**STAFF REPORT
KETCHUM PLANNING AND ZONING COMMISSION
REGULAR MEETING OF JULY 11, 2023**

PROJECT: Miller Residence

FILE NUMBER: P22-046 and P22-046A

APPLICATION TYPE: Mountain Overlay Design Review and Conditional Use Permit

Figure 2: North Elevation Avalanche Retaining Wall Comparison

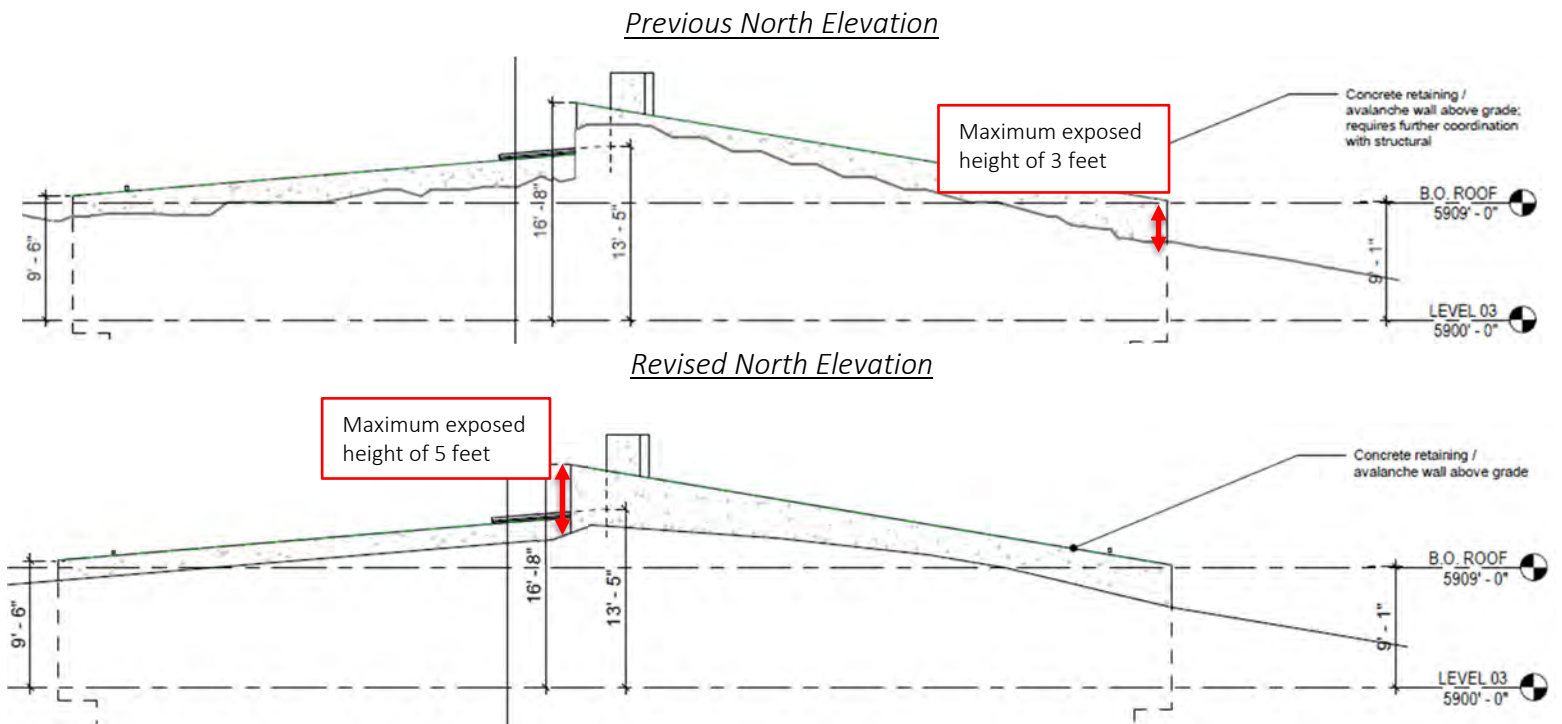
The revised architectural plans, as shown on the north elevation in Attachment B, reflect the wall's exposed height as a result of the change in grading. Please see Figure 2 below for a comparison of the architectural plan's previous and revised illustration of the avalanche retaining wall's exposed height from the north elevation. Previously, the wall had a maximum exposed height of 3 feet above grade (indicated below in red) and the revised plans indicate that the wall's maximum exposed height is 5 feet above grade (indicated below in red).

Figure 2: Project's Roof

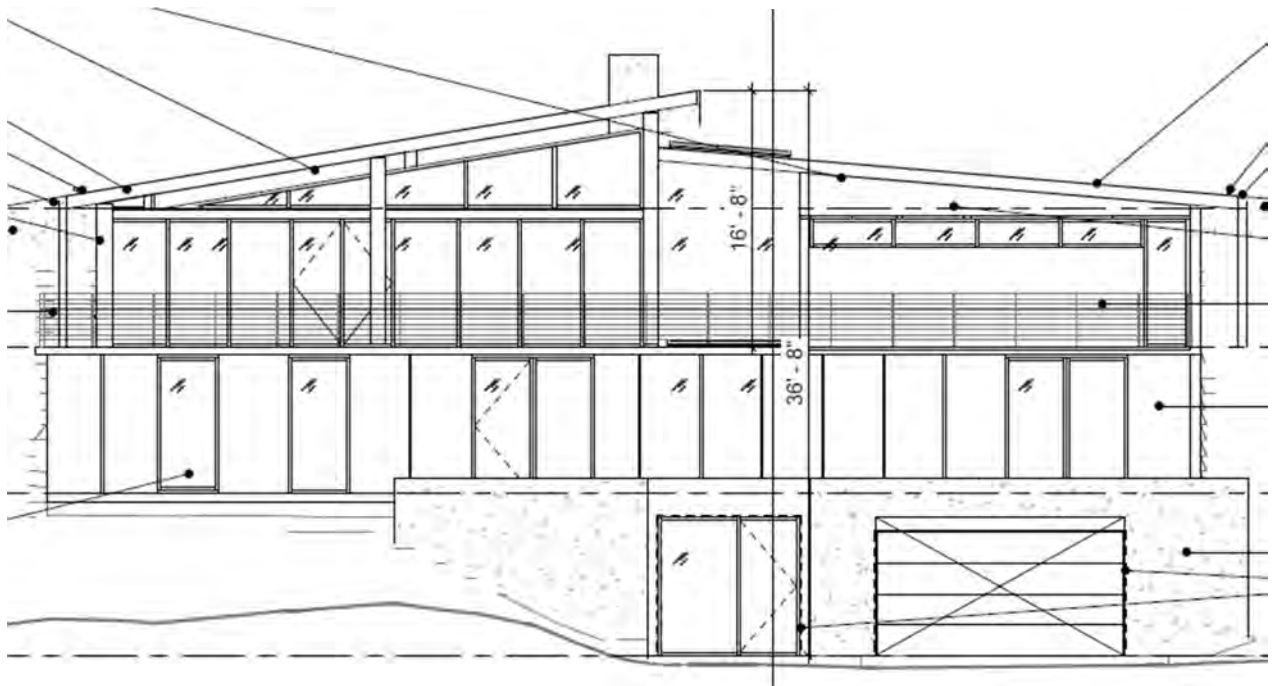
and features a Santa Fe architectural style which has flat roofs with stucco and block forms. The structure to the lookers left is one story in height with pitched roofs and stucco and stone siding. The architectural style of the proposed residence is modern in nature; however, it is complementary of the newer and older residences of the neighborhood as it utilizes wood and steel siding, board formed concrete, large windows, and shed roofs sloped away from each other which presents as a pitched roof. Please see Figure 2 below for details on the proposed roof for the structure. Additionally, pursuant to KMC §17.96.060.F.2 & 5, “The building character shall be clearly defined by the use of architectural features” and “Buildings walls shall provide undulation/relief, thus reducing the appearance of bulk and flatness.” The proposed residence is three stories in height and each floor of the structure is stepped back into the hillside, providing undulation and relief to reduce the appearance of bulk and flatness.

Figure 3: Project's Front Lot Lines and Front Setback

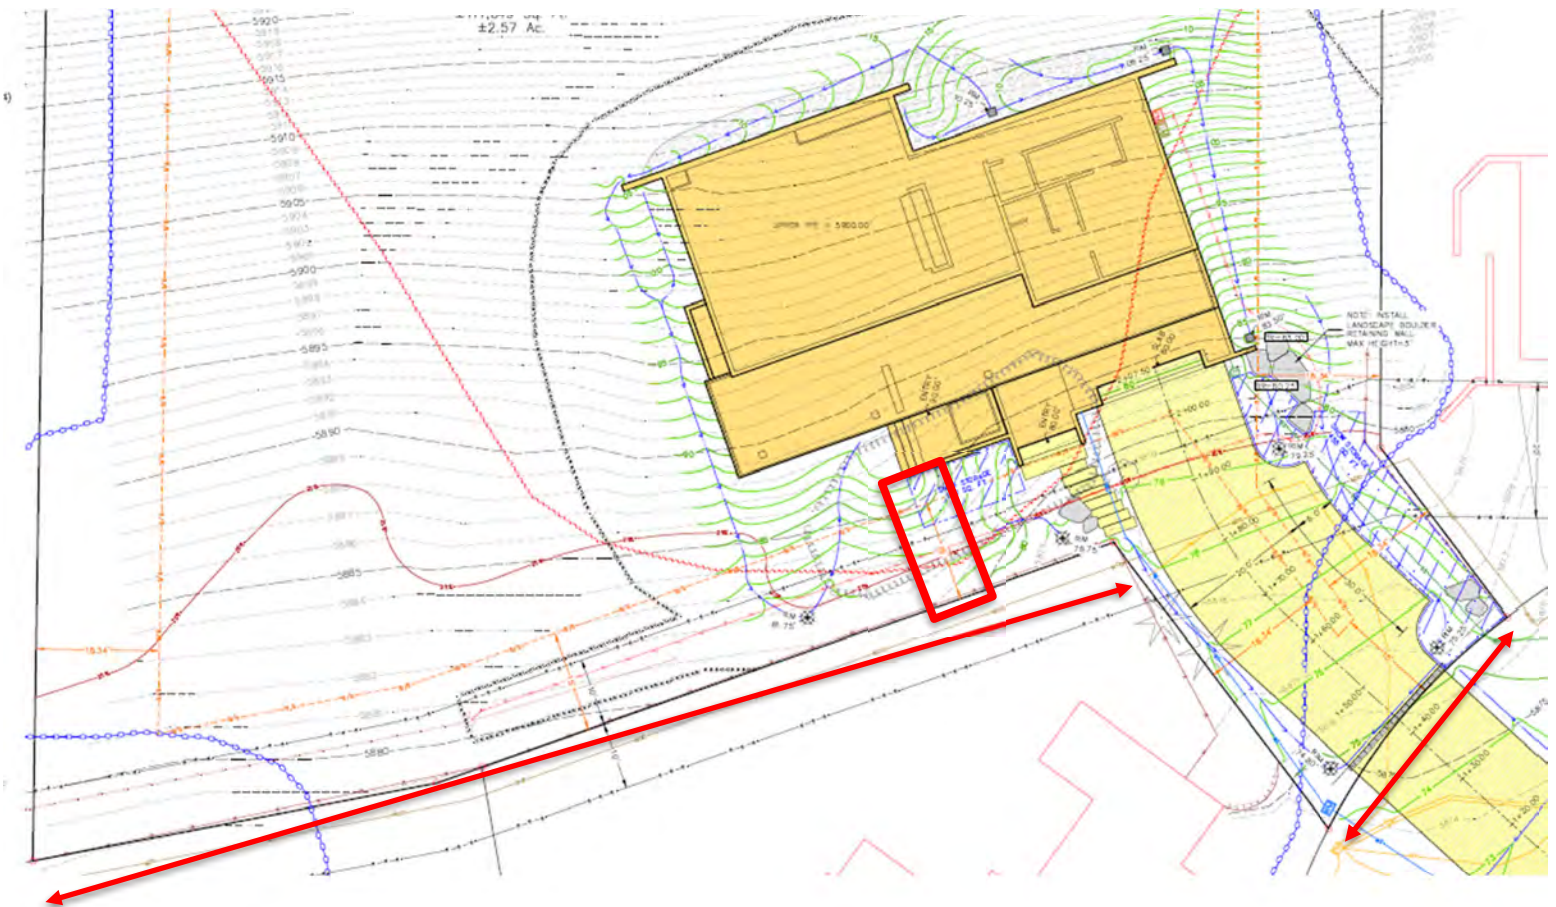
The KMC defines minimum setbacks for the front, side, and rear lot lines for each project. The KMC defines the "lot line, front" as "The property line dividing a lot from a street. On a corner lot, only one street line shall be considered as a front line, and the shorter street frontage shall be considered the front line, unless otherwise determined by the administrator based on the orientation and layout of the lot and surrounding neighborhood." There are two front lot lines for the subject property. The lot is situated behind two existing single-family homes and is uniquely shaped with a narrow entrance between the two lots to access the subject property. The proposed residence is setback 15 feet from the longer of the two front lot lines, which is setback at the lowest possible elevation. Please see Figure 3 below which outlines the two front lot lines and front yard setback in red.
